Project Title: Refurbish Elevators and Replace Controls

Solicitation Questions and Answers
for
Refurbish Elevators and Replace Controls
Project: 437-22-101, RFP: 36C26324R0021
12/15/2024

Solicitation Questions and Answers (updated 3-26-2024) for
 Refurbish Elevators and Replace Controls
 Project: 437-22-101, RFP: 36C26324R0021

4 FLOOR PLAN - INDEPENDENCE 4,5 - DEMOLITION TYPICAL
1/4" = 1'-0"

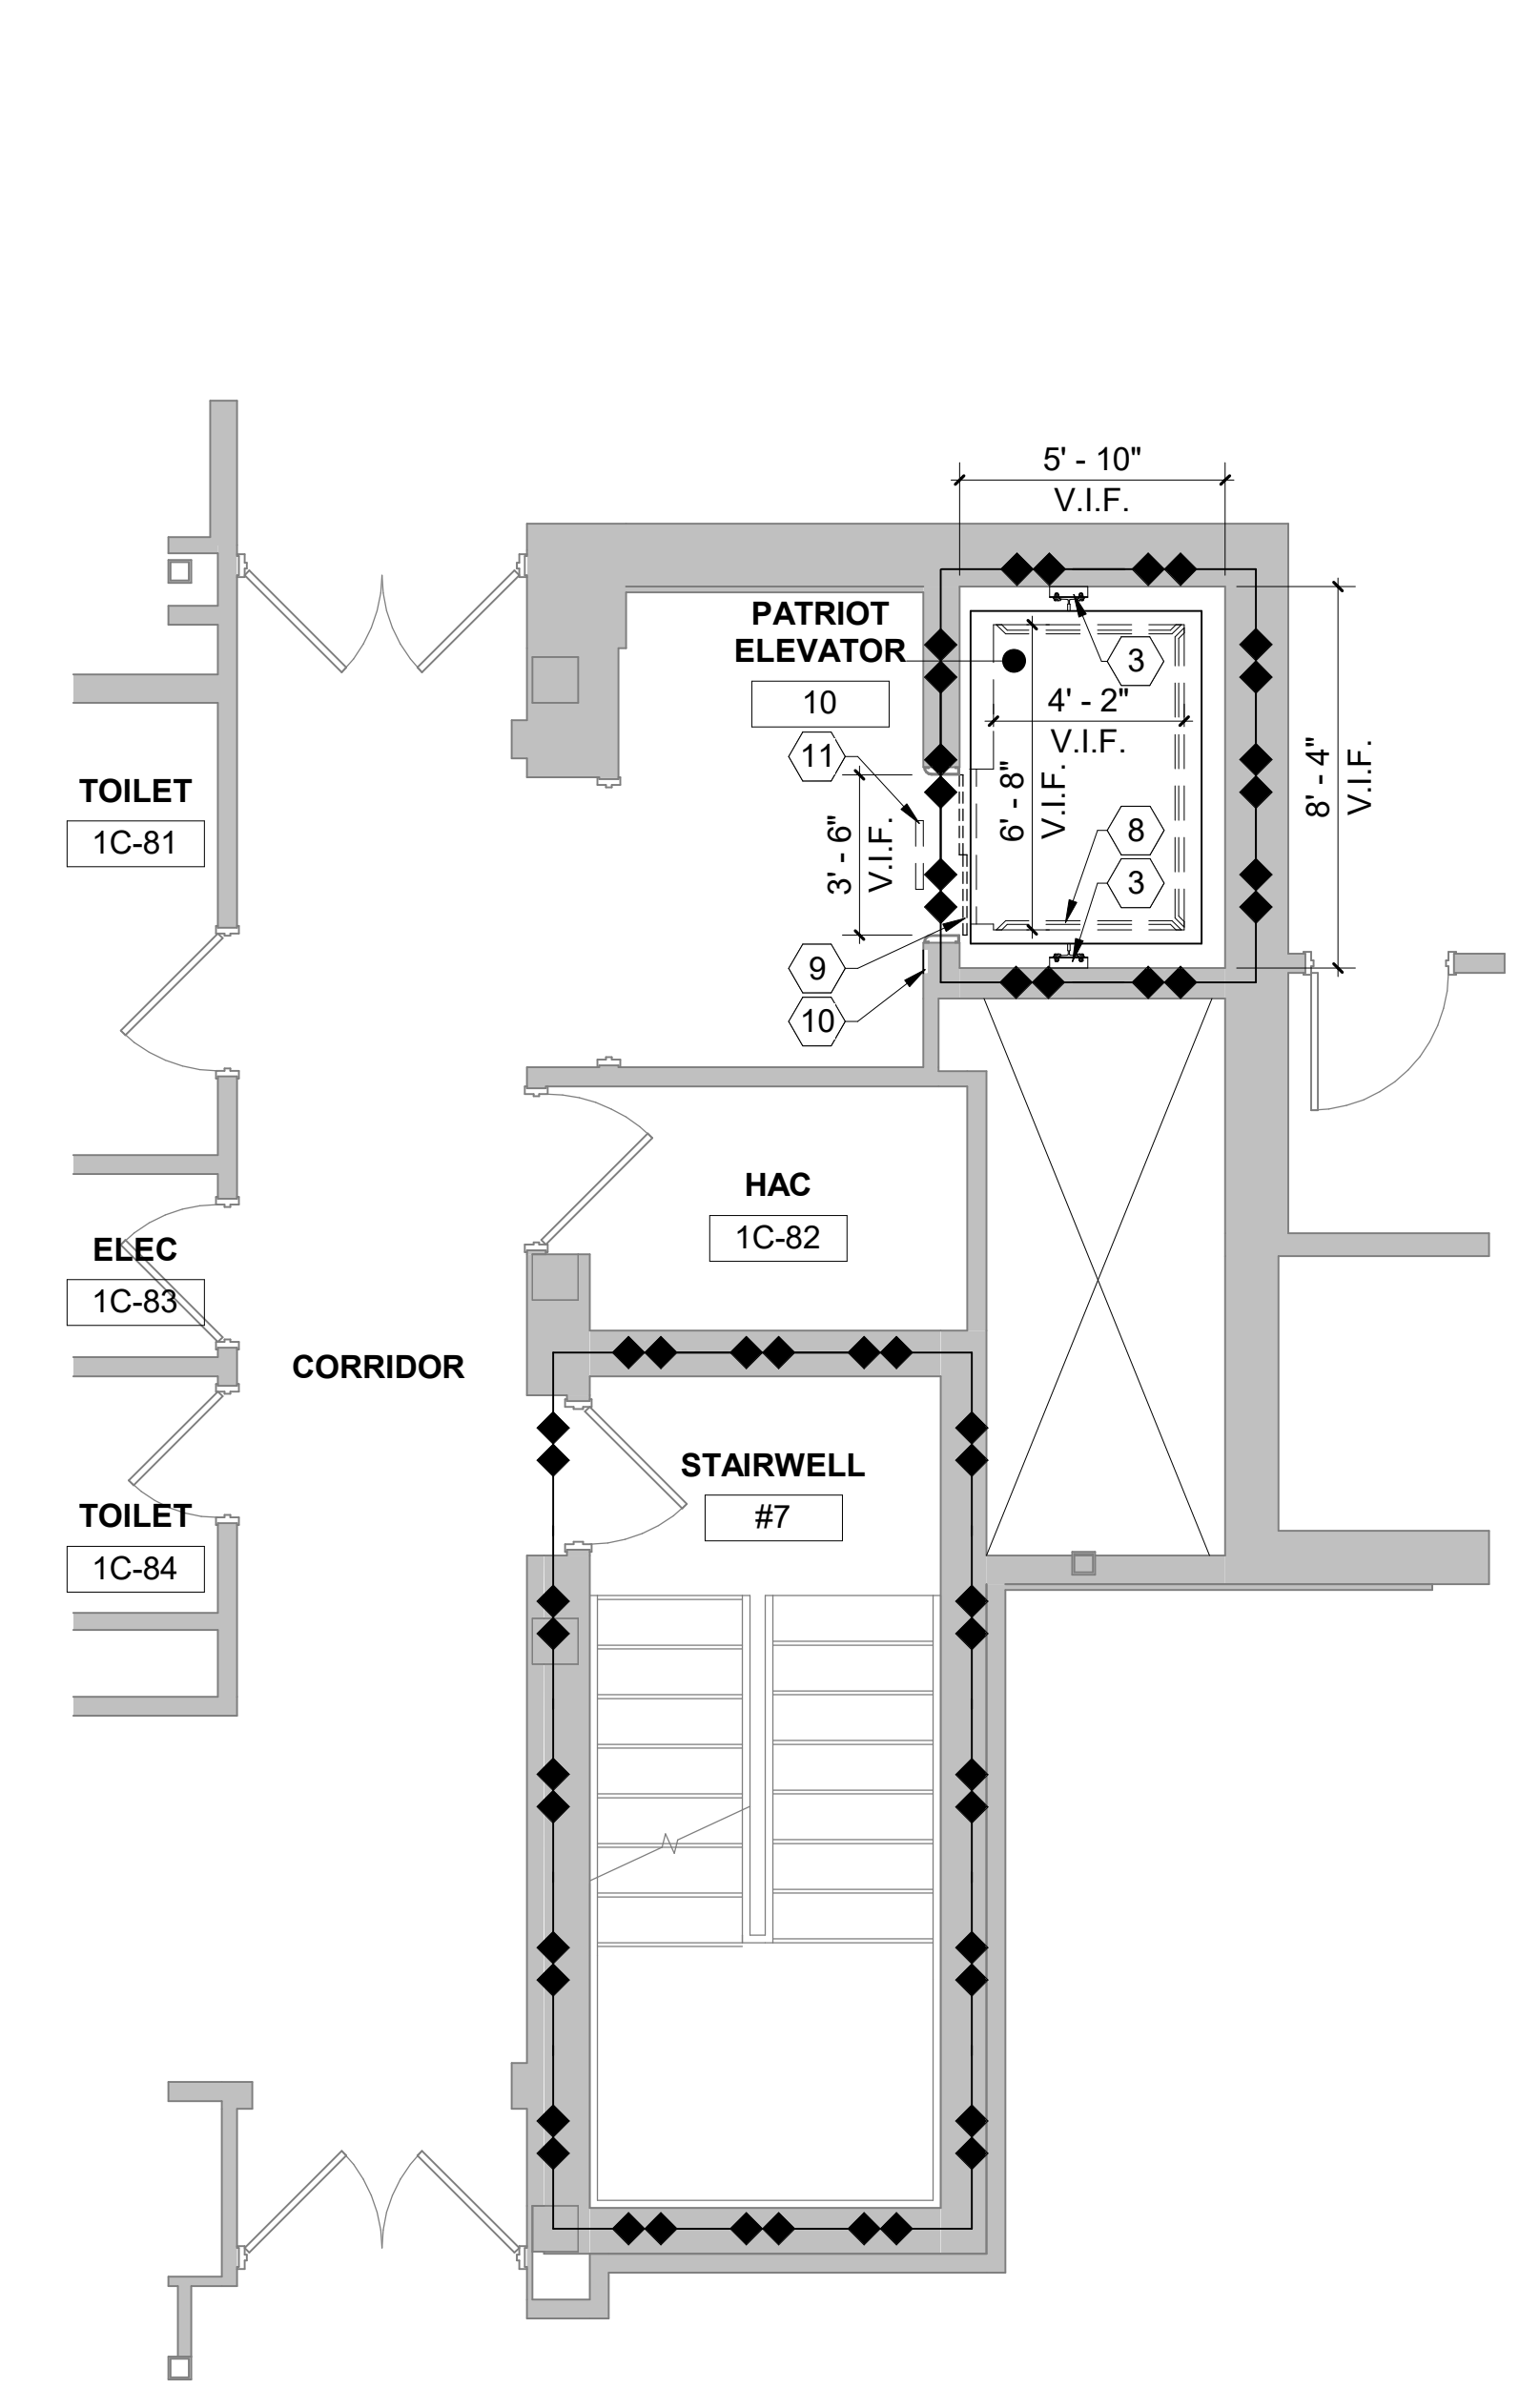
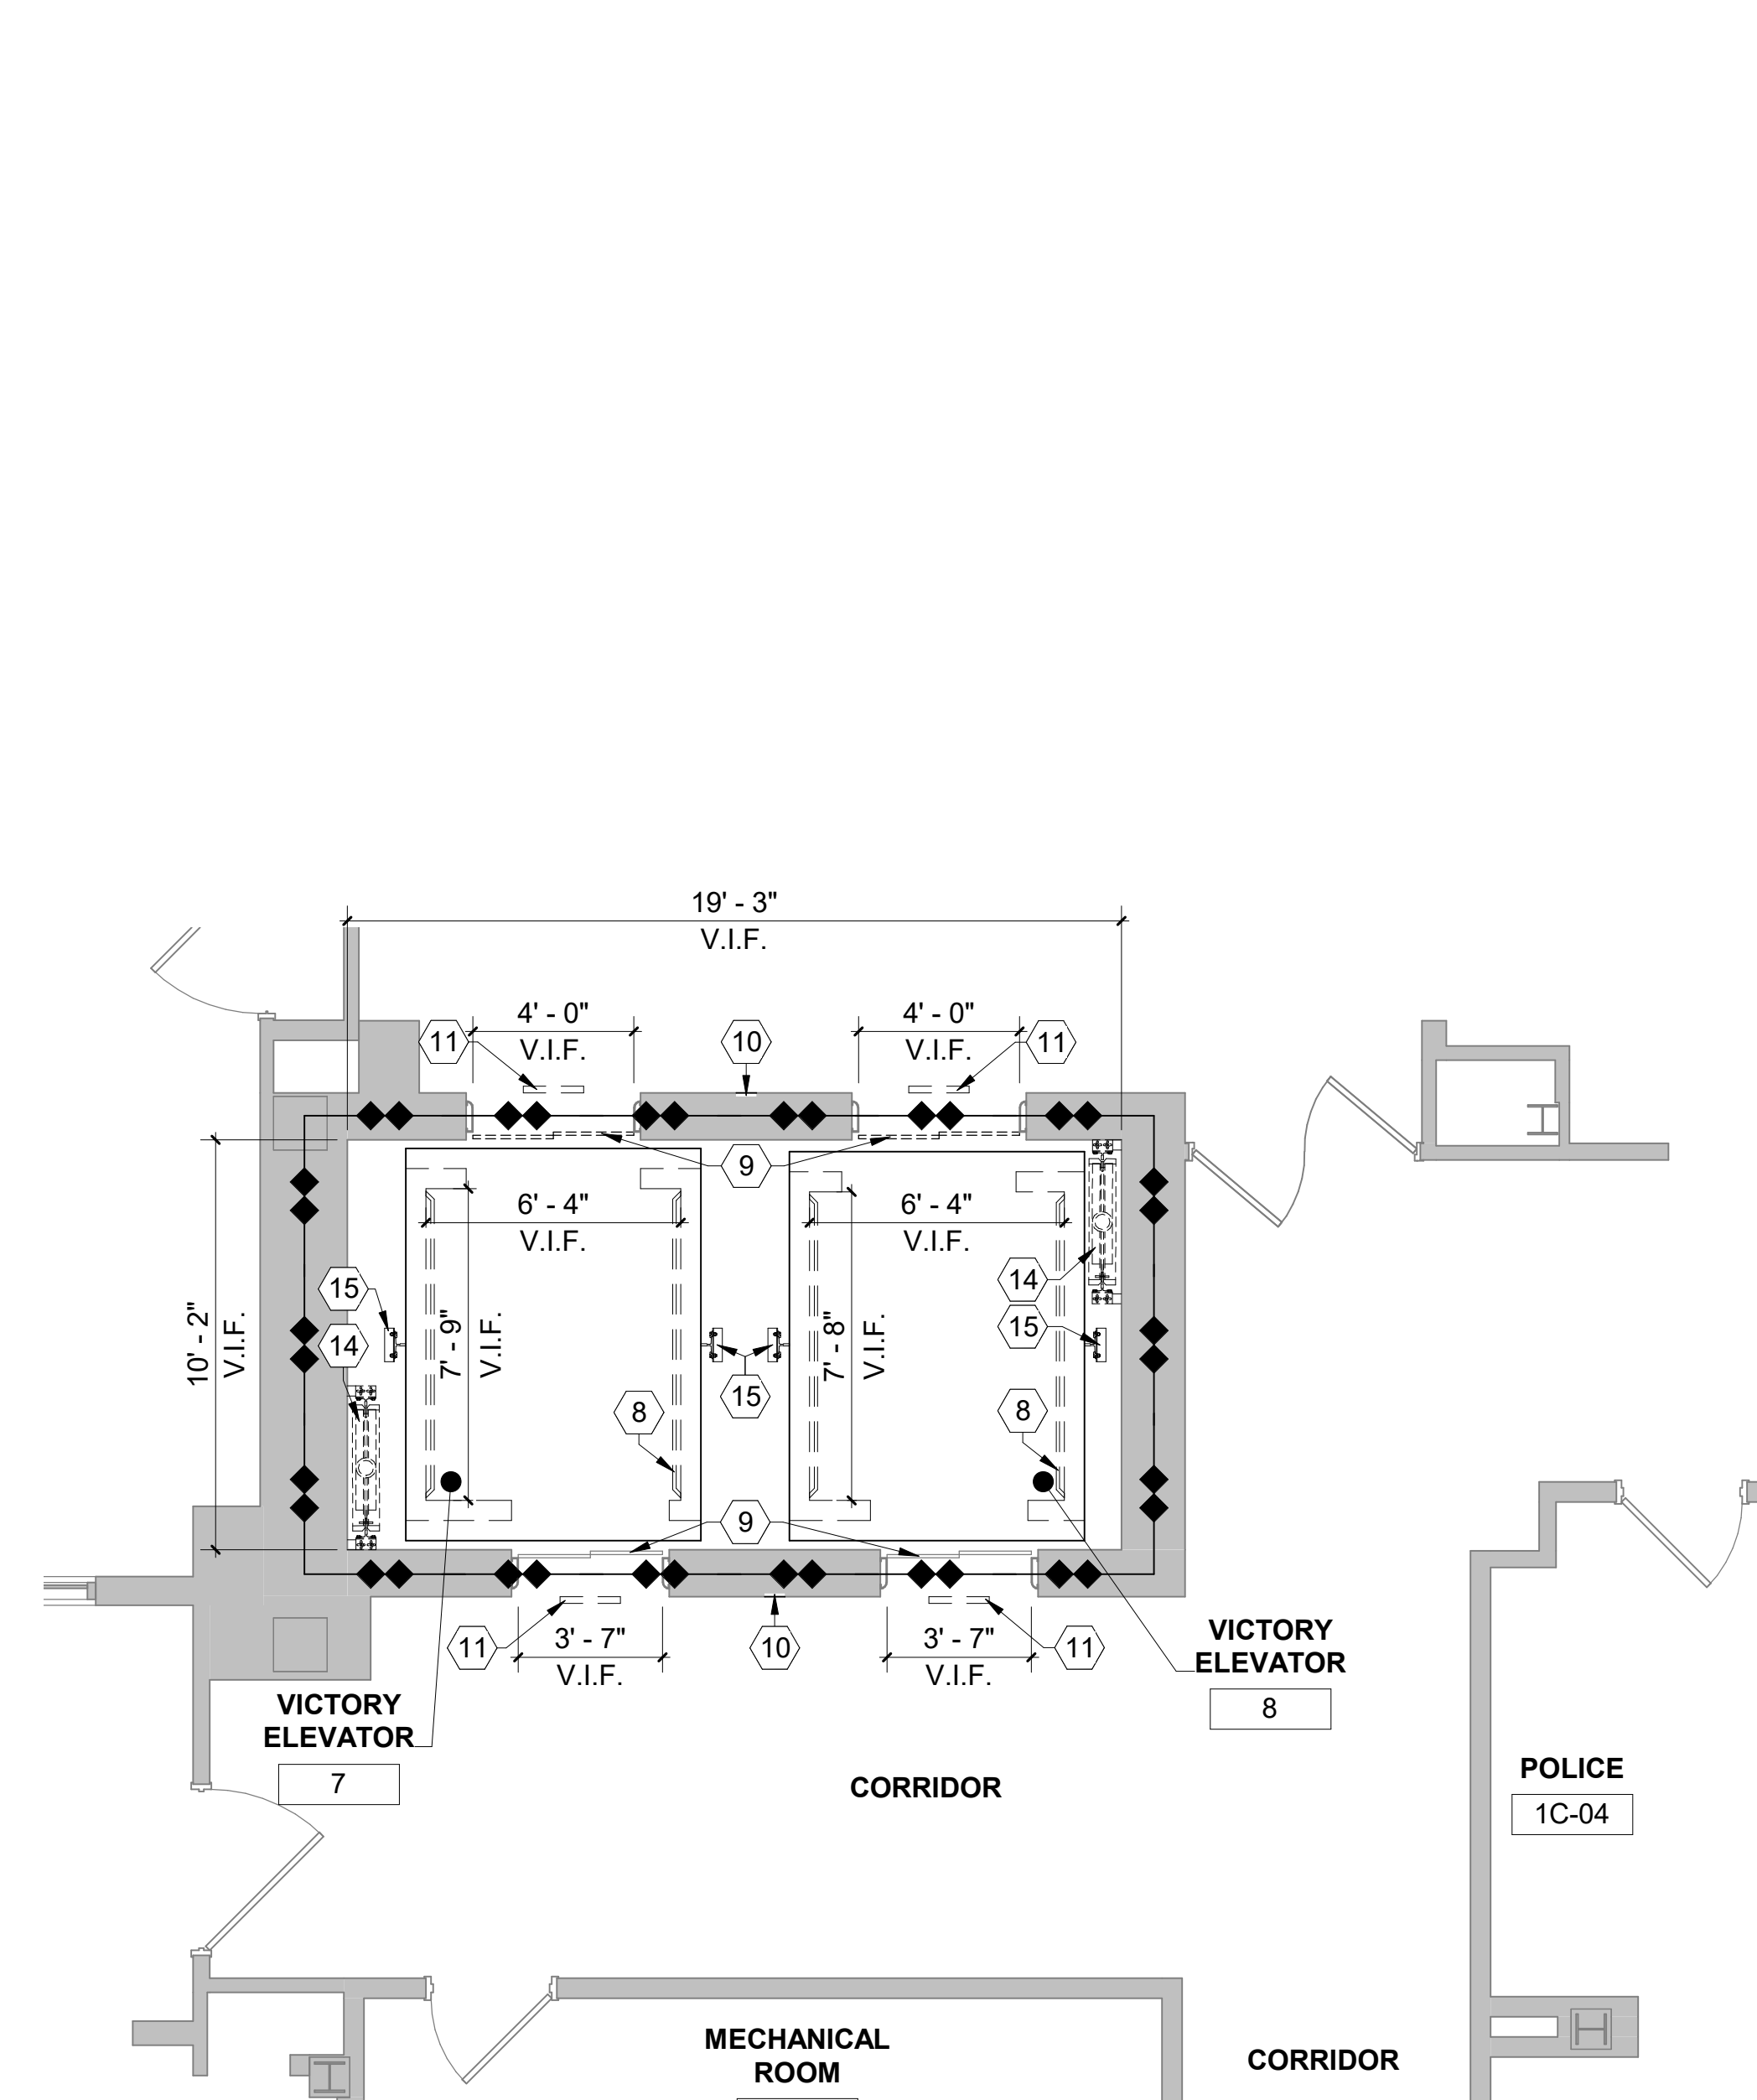
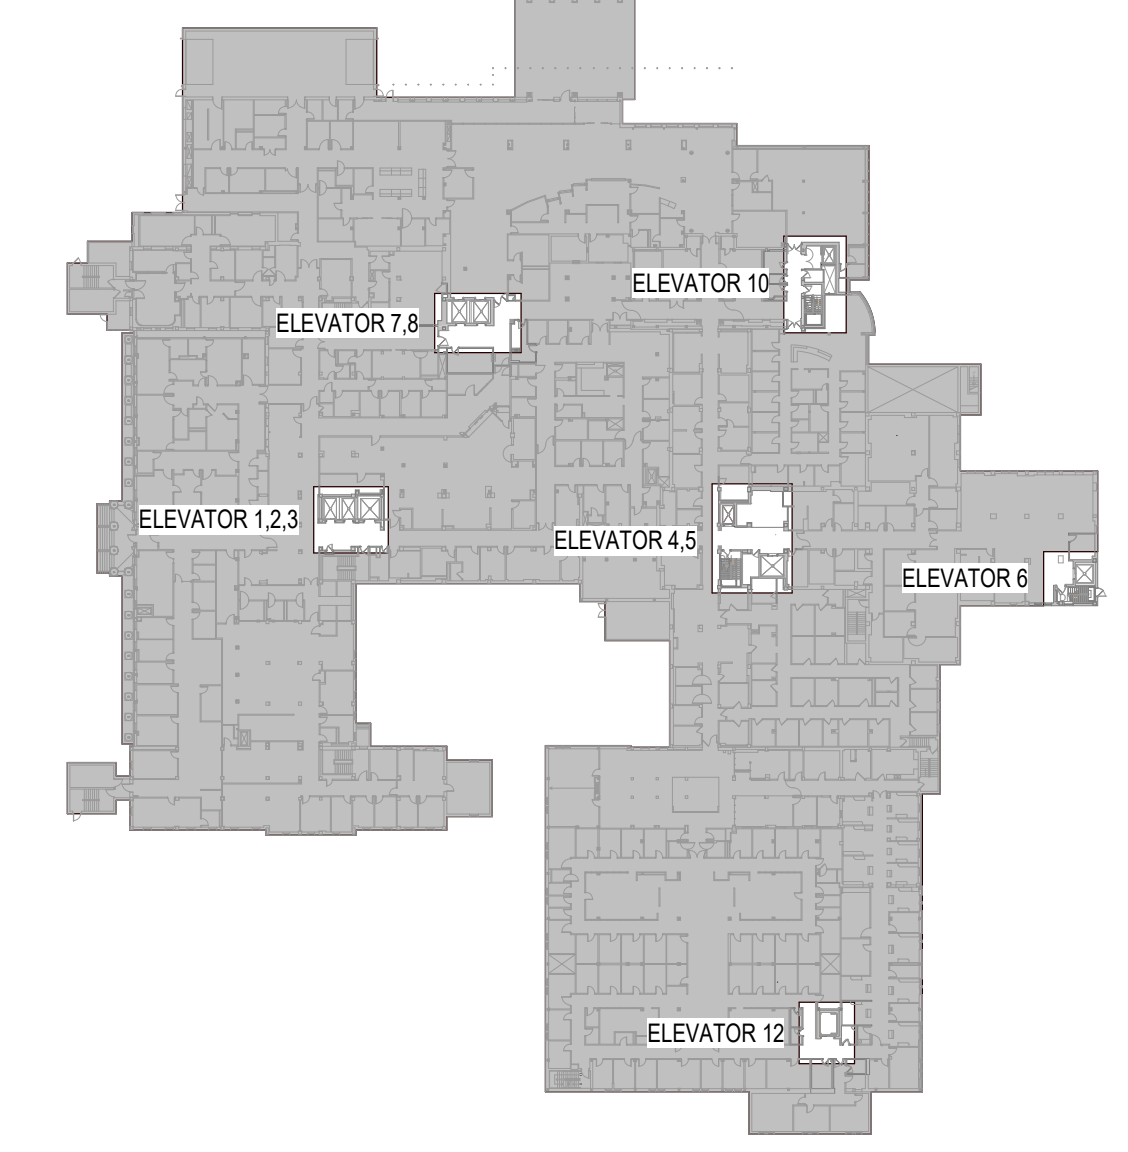
55.	Drawing AD5.21 Key note #14	<p>Replace counterweight assemblies Per the drawings the full counterweights are to be replaced but it is not in the specifications. Which takes precedence?</p>	Note 7 on drawing sheet AD5.20 states that the existing counterweight assemblies are to remain.

56.	Drawing AD5.21 Key note #15	<p>Replacement of the rails on elevators 7&8: During the walkthrough is was discussed by all parties that there might be a revision to the specification to only replace the bottom rail in the car and counterweight stack since that was the only pieces affected by water. Will the specification be revised to include the bottom rail only? Please note removal of the rails will require the entire elevator to be disassembled and removed from the shaft and require and extended downtime.</p>	<i>See Response to Question #47</i>

Drawing Sheet AD5.21 ENLARGED PLANS - DEMOLITION – See revised drawing sheet for the inclusion of additional floor demo to support the installation of underfloor plumbing at Elevator #10.

Drawing Sheet AD5.21 ENLARGED PLANS - DEMOLITION – See revised drawing sheet for the adjustment of keynotes # 3, 9, 14, 15.
